**Technical Service  
Information Bulletin**

# ECM CALIBRATION: SHIFT FEELING ENHANCEMENT

'04 - '05 RX 330

TC005-03

Calibration  
Identification  
Chart

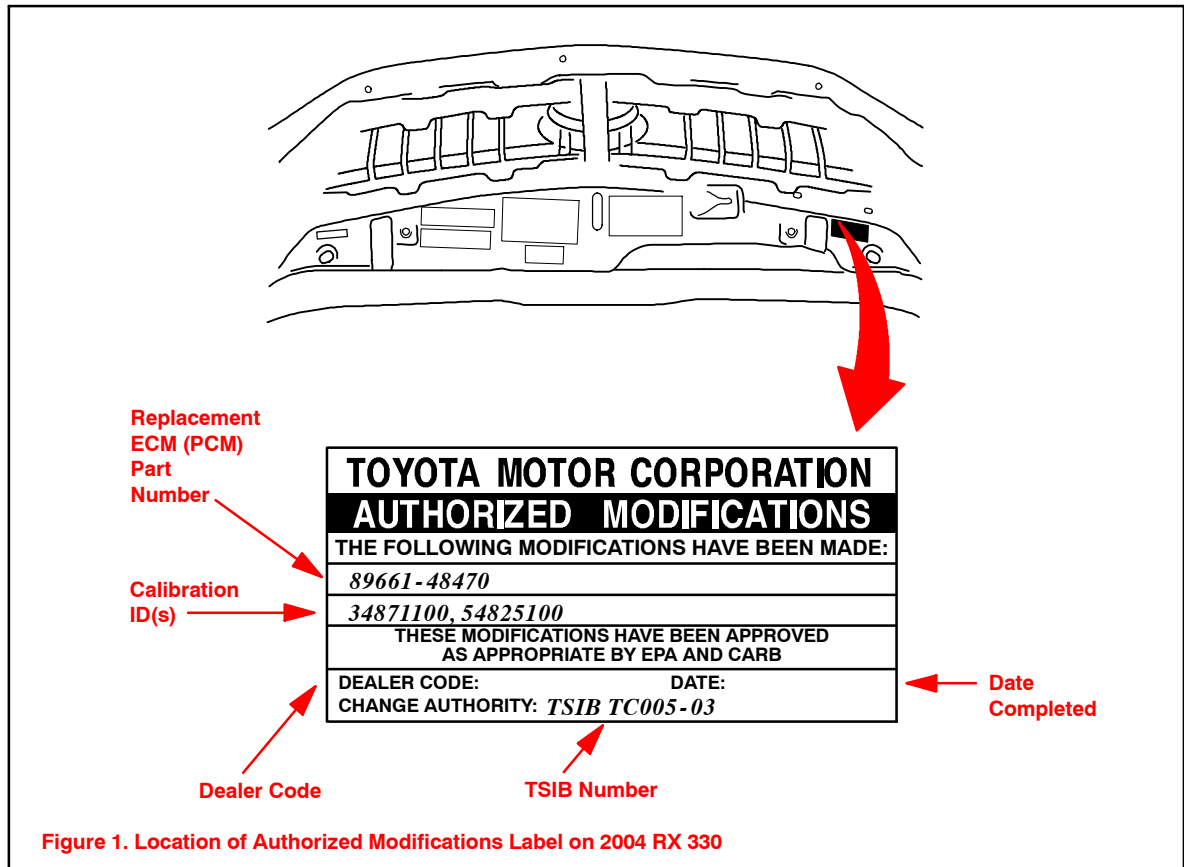
- February 9, 2006:
  - The Calibration Identification Chart has been updated to include ALL 2005 model year RX 330 calibration IDs. Previous versions of this TSIB would not allow updating of RX 330 vehicles built in the later part of 2005 model year.  
NOTE: If a vehicle has already been reprogrammed following a previous version of TSIB No. TC005-03, further updates are NOT required.

- May 20, 2005: The following changes have been implemented since first publication: 2005 model year RX 330 vehicles added to Applicable Vehicles. Introduction and Note updated on page 1. New part, Brake Actuator Assembly, added. Calibration Identification Chart updated to include 2005 model year RX 330 calibration IDs. Repair Procedure expanded with instructions for vehicles with laser cruise control.
